Product Change Notification

Product Change Notification: PCN-26-287891

T92 series relays

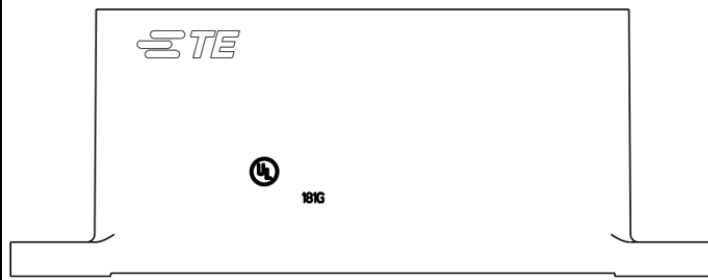
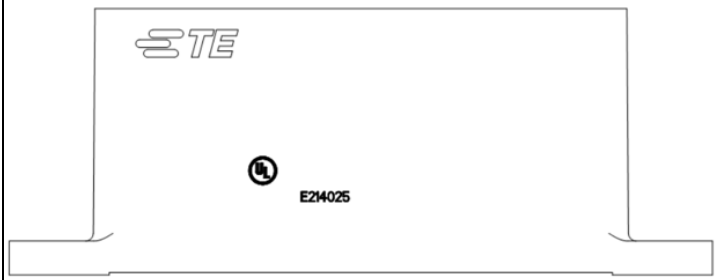
Marking change before :

Marking Change after:

Align with the latest requirements of the UL certification body. The marking contents change only from 181G to E214025 , others keep unchanged.
